STATE OF HAWAII
DEPARTMENT OF TRANSPORTATION
HIGHWAYS DIVISION

ADDENDUM NO. 2

**INTERSTATE ROUTE H-1 ADDITION AND MODIFICATION OF FREEWAY ACCESS
(KAPOLEI INTERCHANGE COMPLEX), PHASE 3**

FEDERAL-AID PROJECT NO. NH-H1-1(271)

3
RS-10

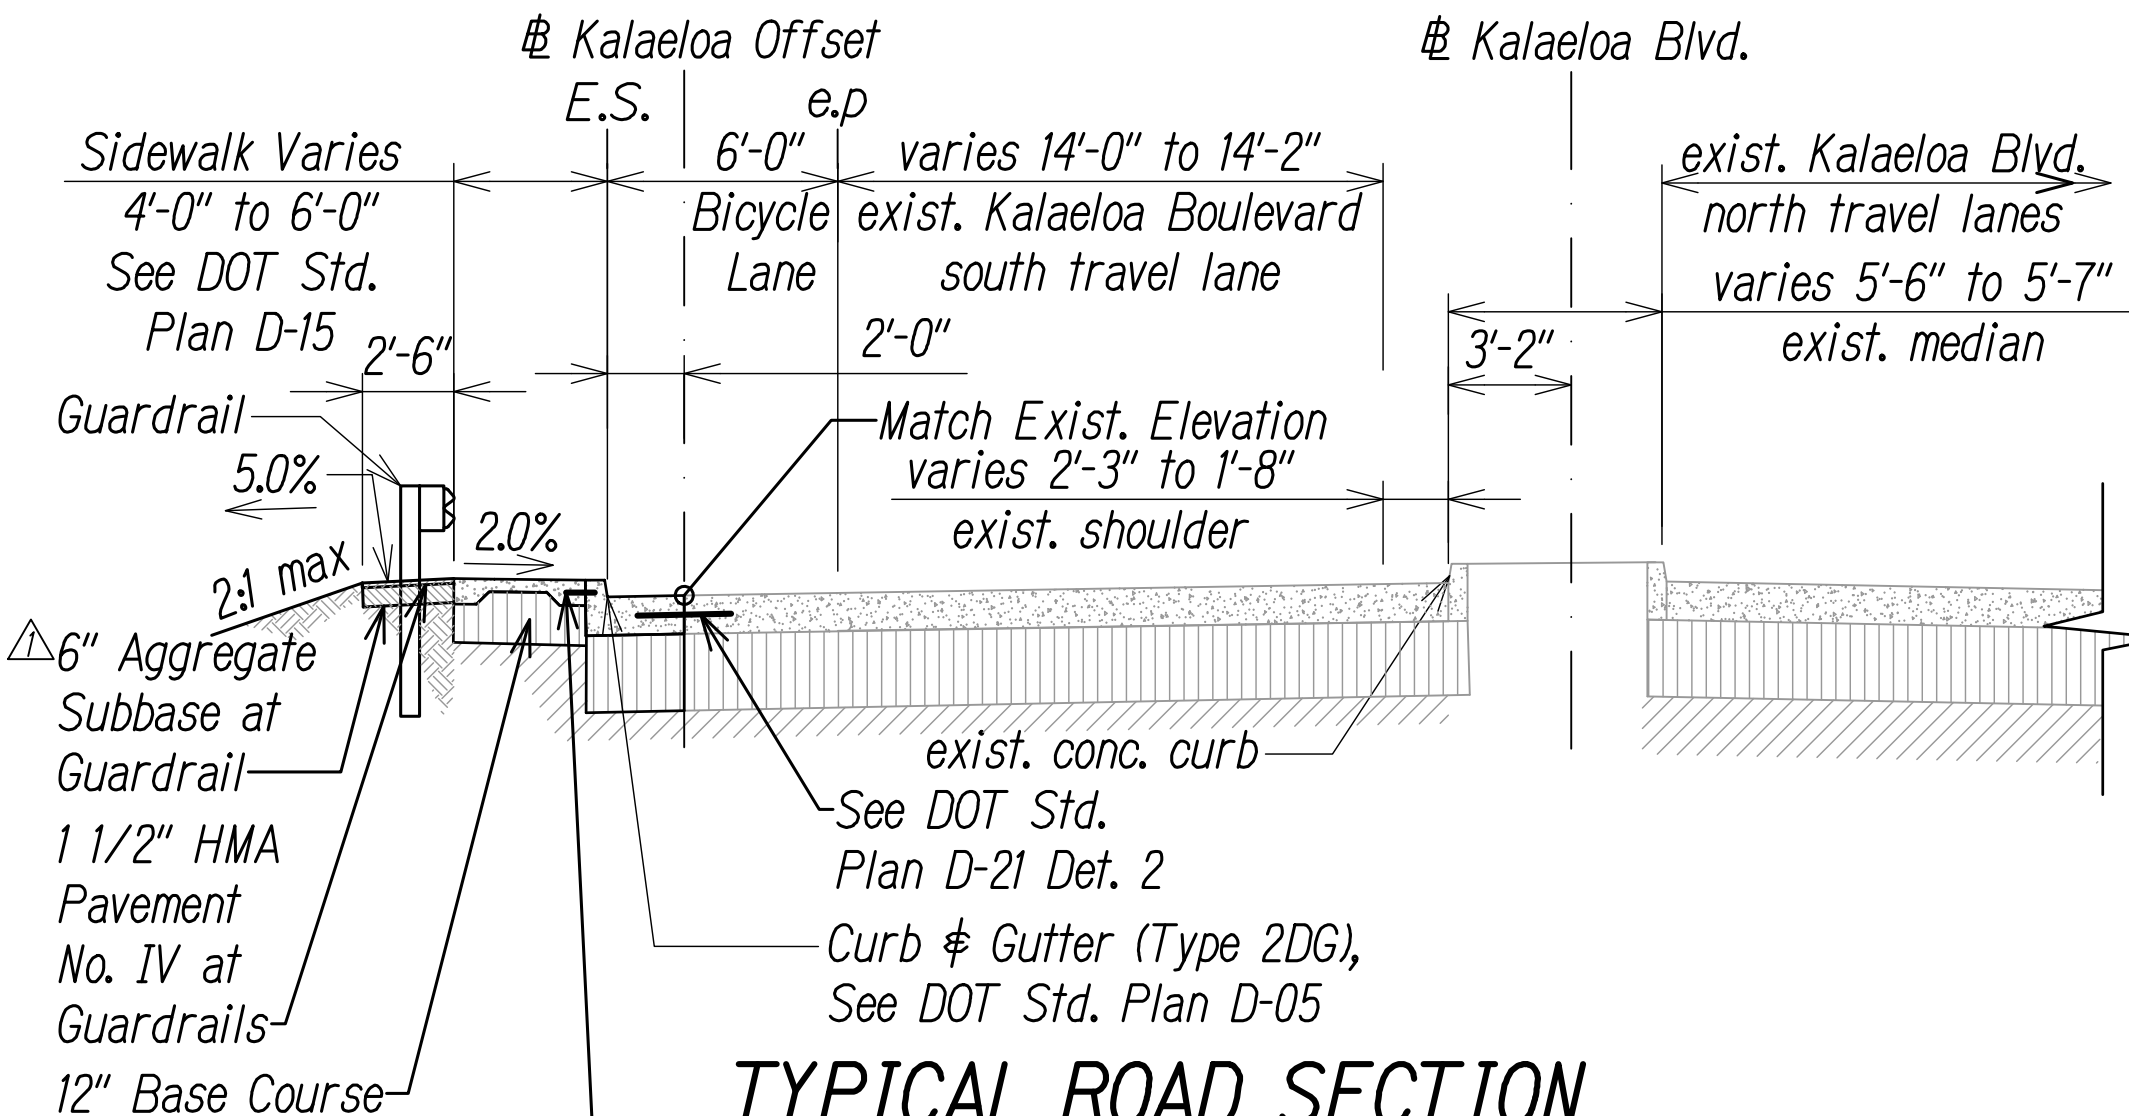
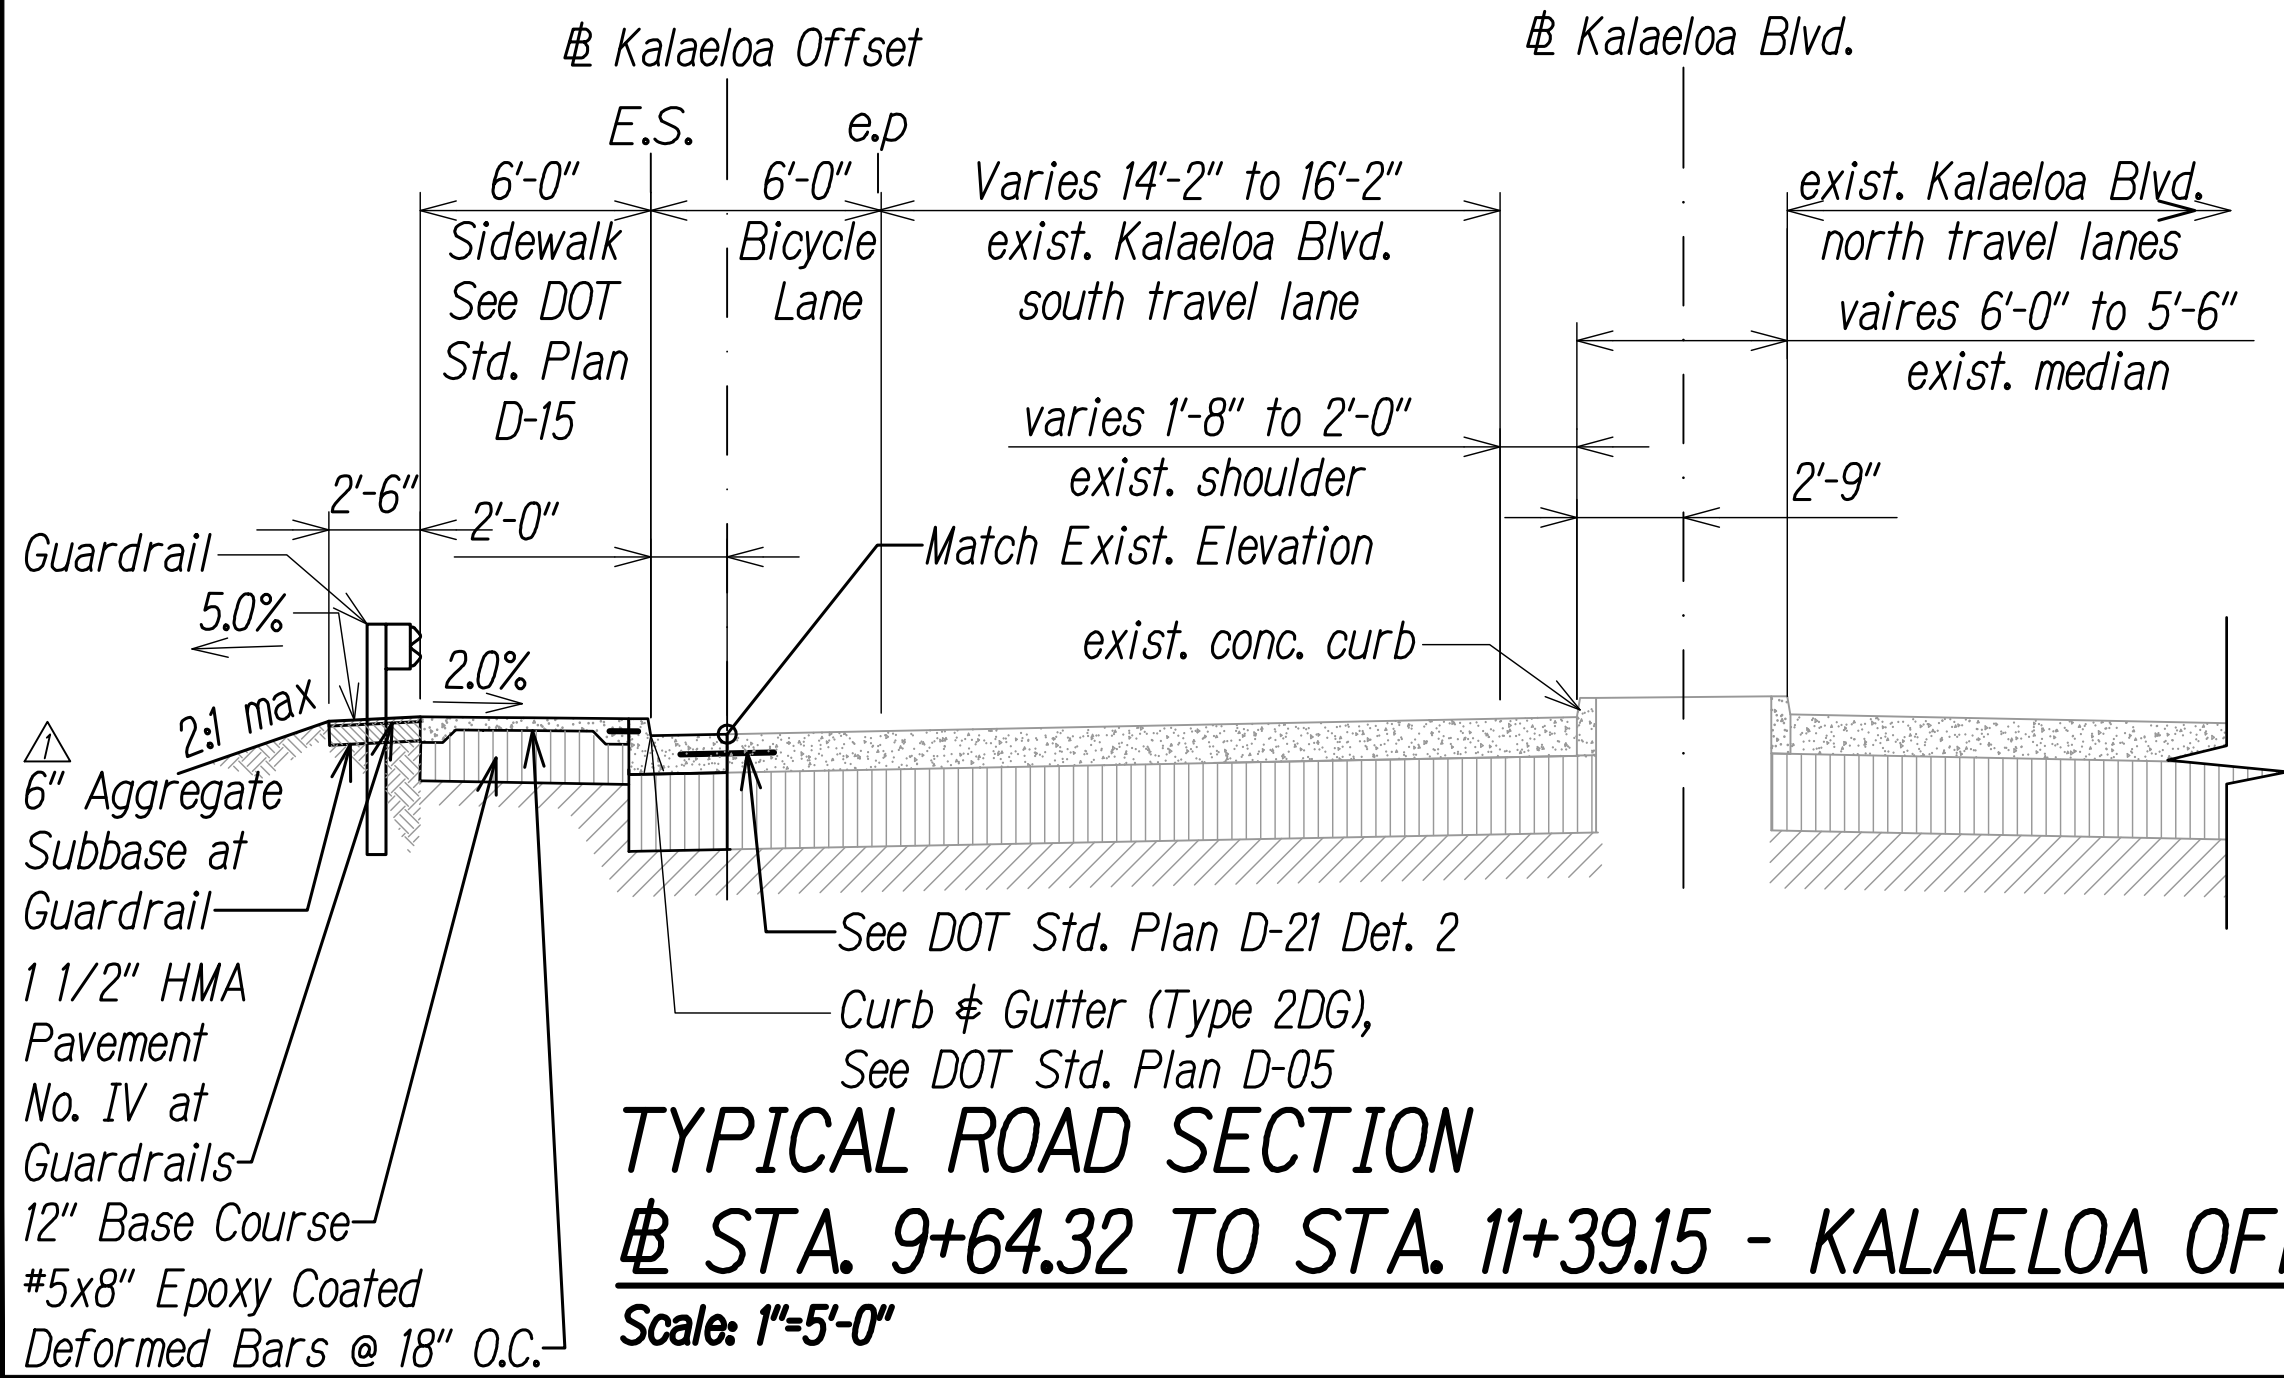
Added 6" Aggregate Subbase at guardrails	10/21/2022
REVISION	DATE
STATE OF HAWAII DEPARTMENT OF TRANSPORTATION HIGHWAYS DIVISION	
TYPICAL SECTIONS 10	
INTERSTATE ROUTE H-1 ADDITION AND MODIFICATION OF FREEWAY ACCESS (Kapolei Interchange Complex), Phase 3 Federal Aid Project No. NH-HI-K(271)	
Scale: As Noted	Date: August 2022
SHEET No. RS-10 OF 167 SHEETS

FED. ROAD DIST. NO.	STATE	FED. AID PROJ. NO.	FISCAL YEAR	SHEET NO.	TOTAL SHEETS
HAWAII	HAW.	NH-HI-K(271)	2022	ADD. 44	167

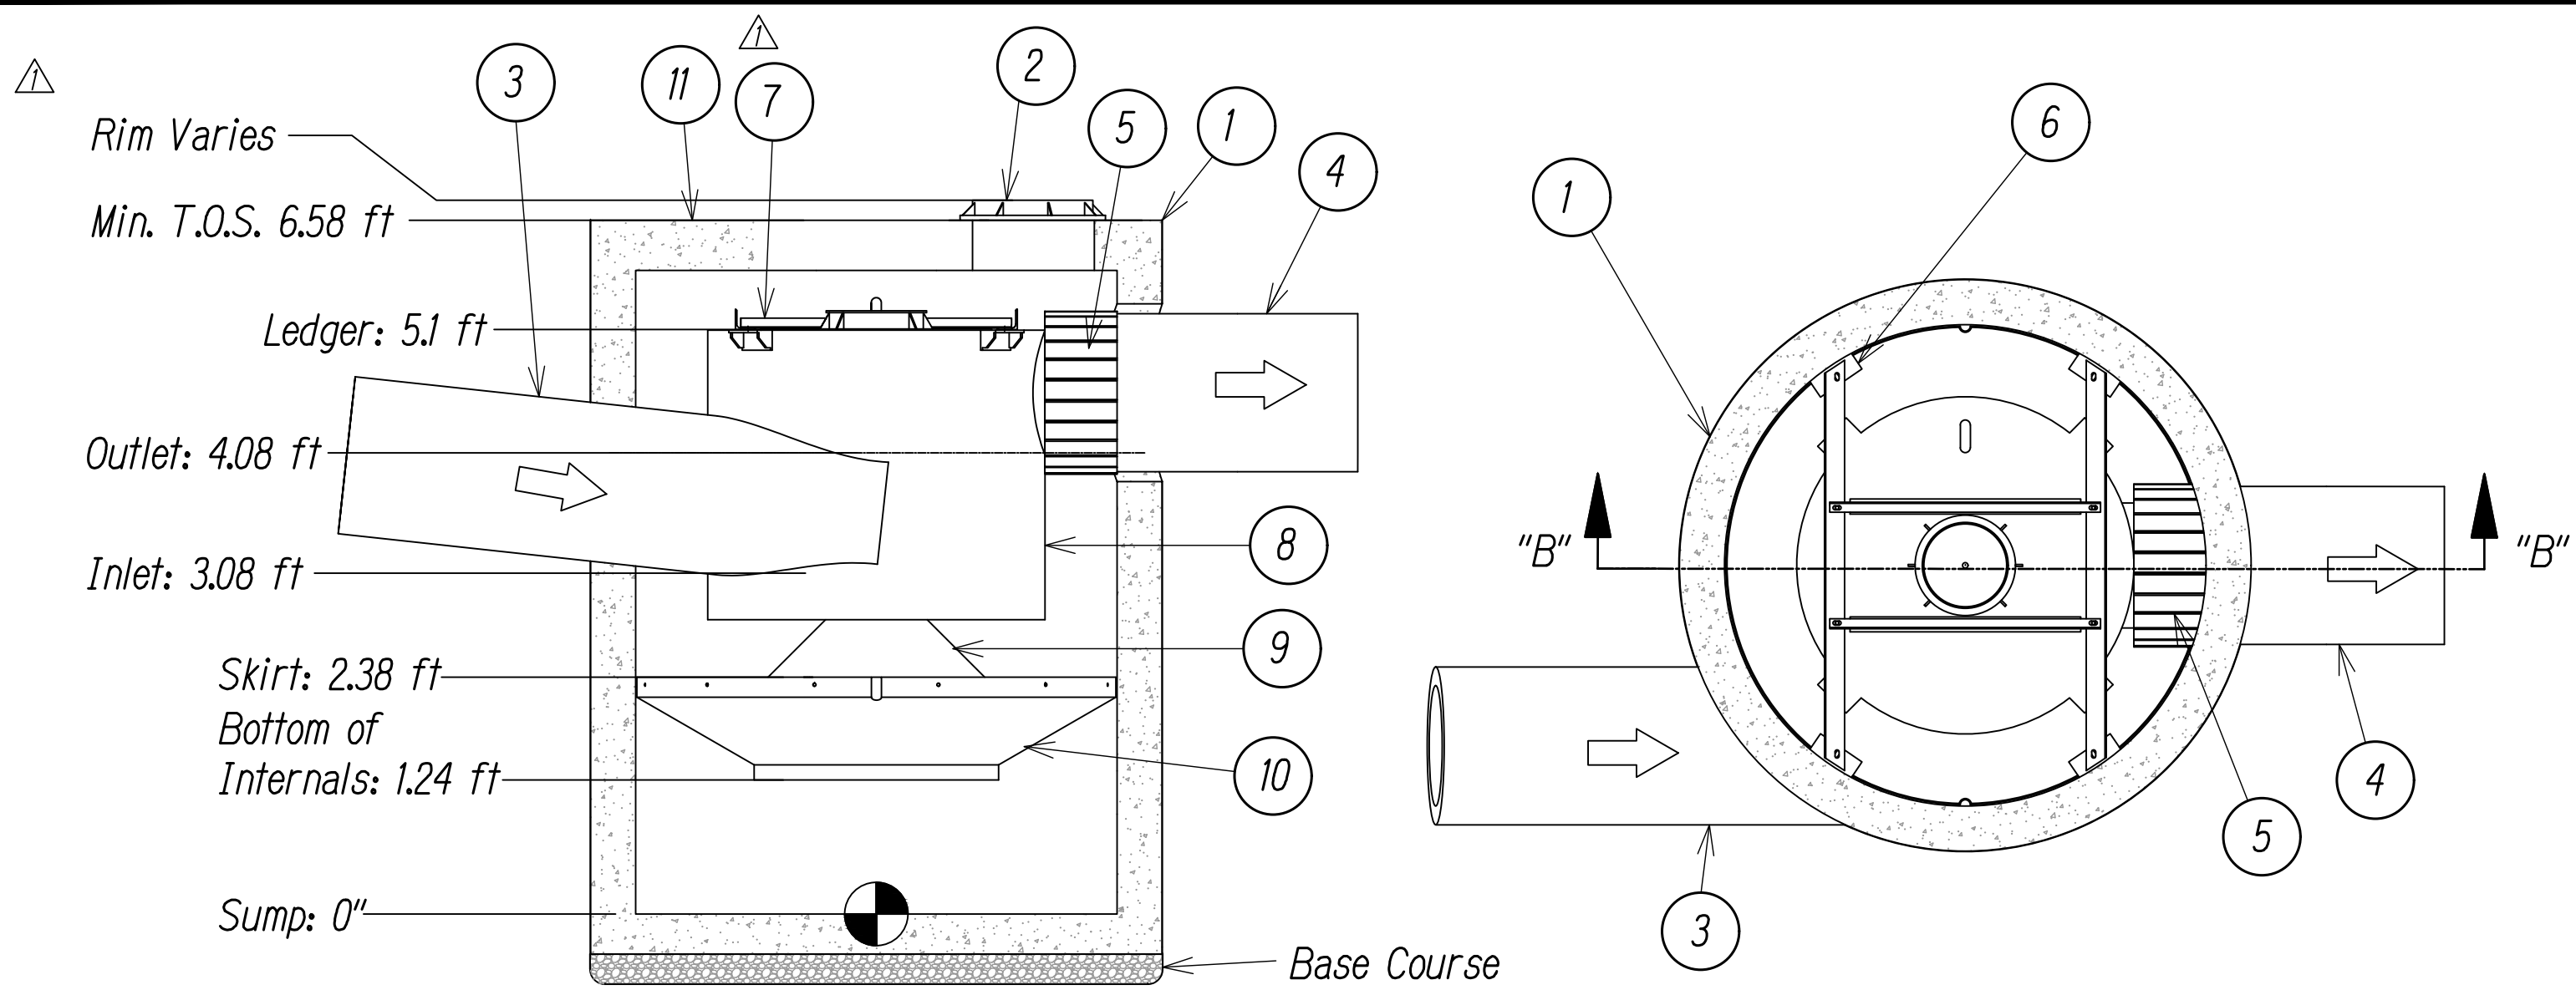
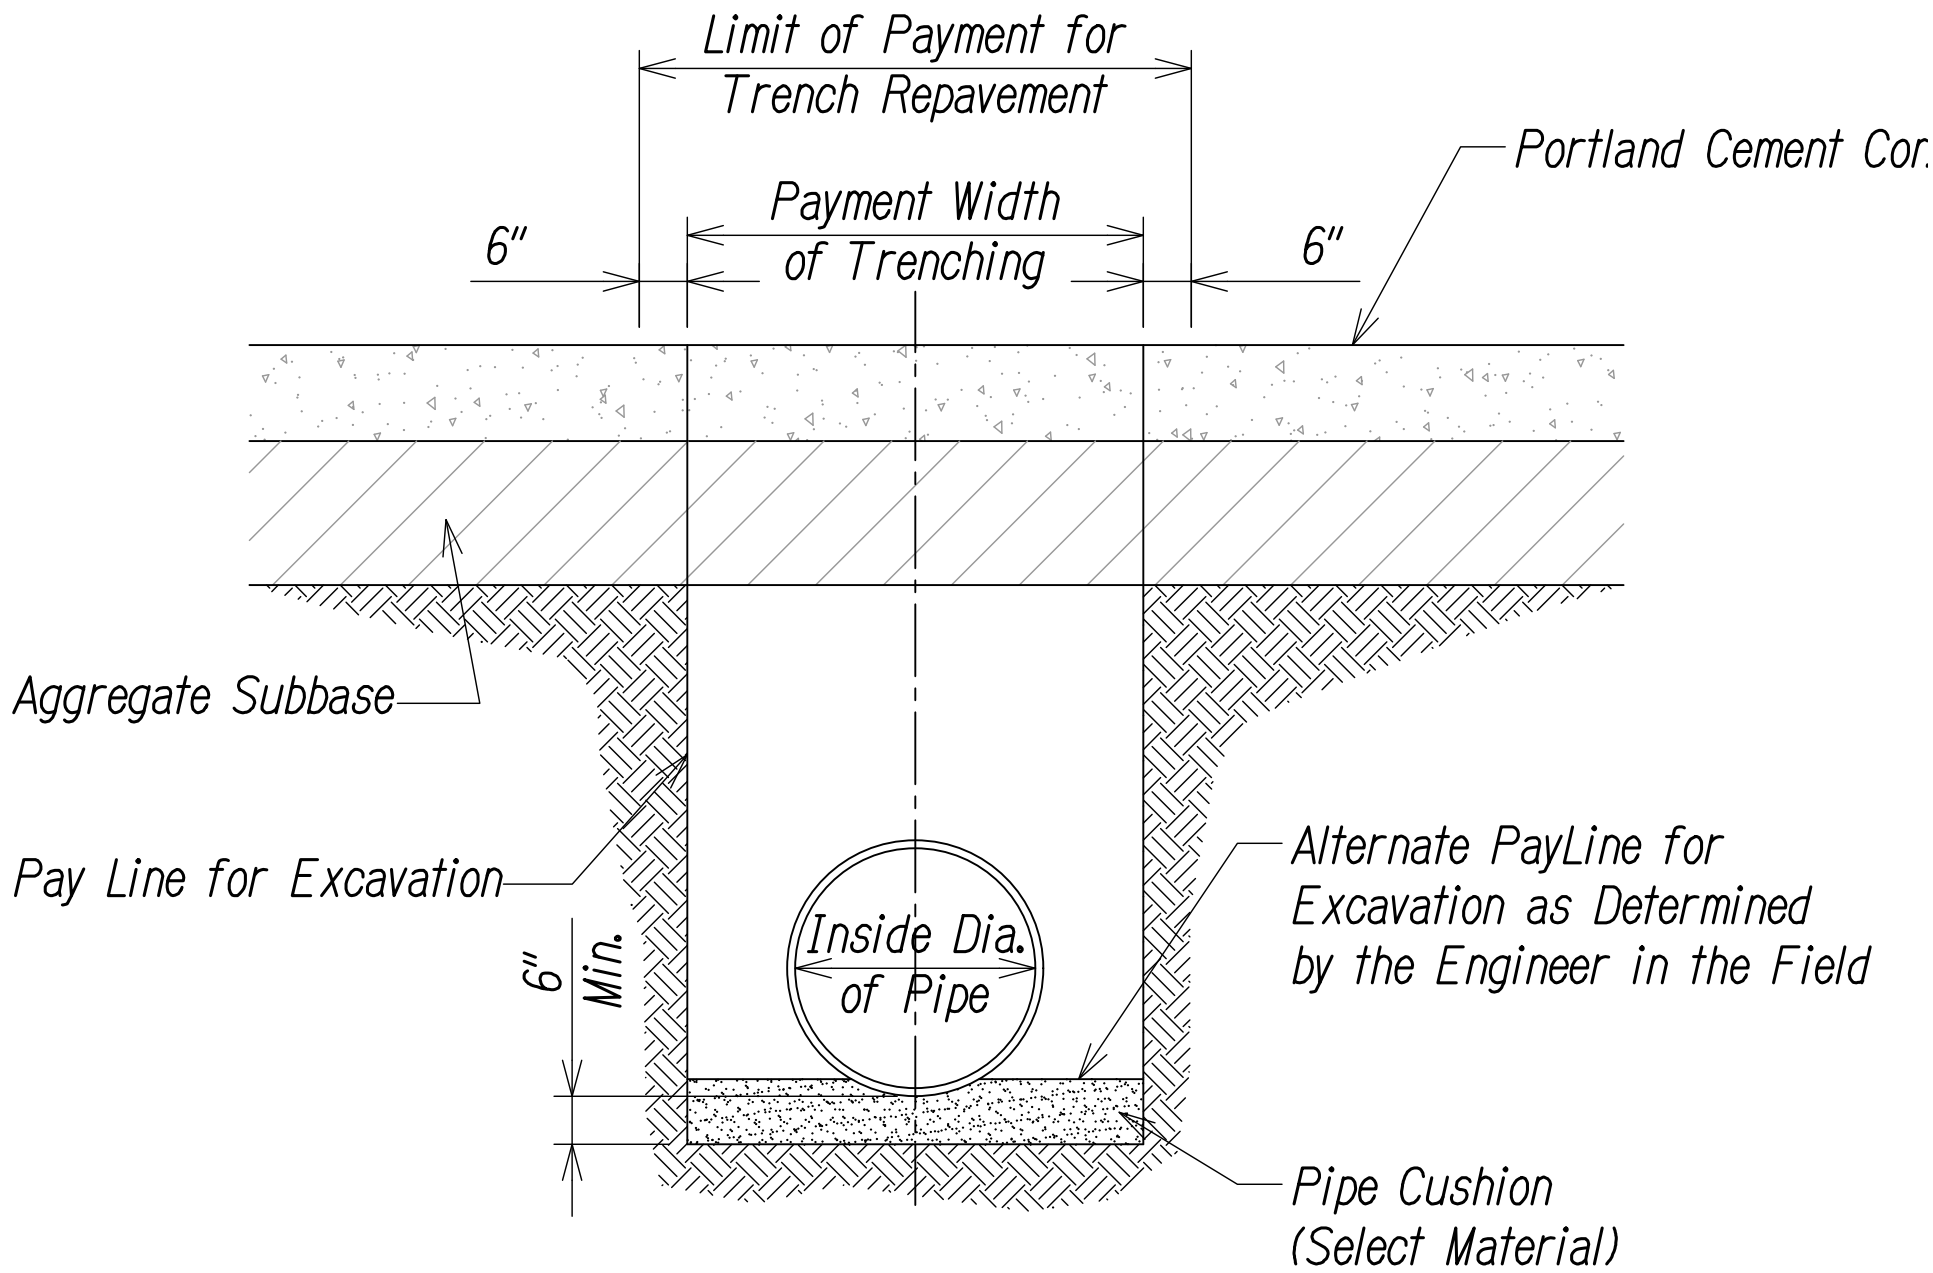
DATE	10/21/2022	REVISION	Revised det 1 from 6' to 4', removed det 3 removed pipe size from det 4
STATE OF HAWAII DEPARTMENT OF TRANSPORTATION HIGHWAYS DIVISION			
DRAINAGE DETAILS 1			
INTERSTATE ROUTE H-1 ADDITION AND MODIFICATION OF FREEWAY ACCESS (Kapolei Interchange Complex), Phase 3 Federal Aid Project No. NH-HI-K(271)			
Scale: As Noted		Date: August 2022
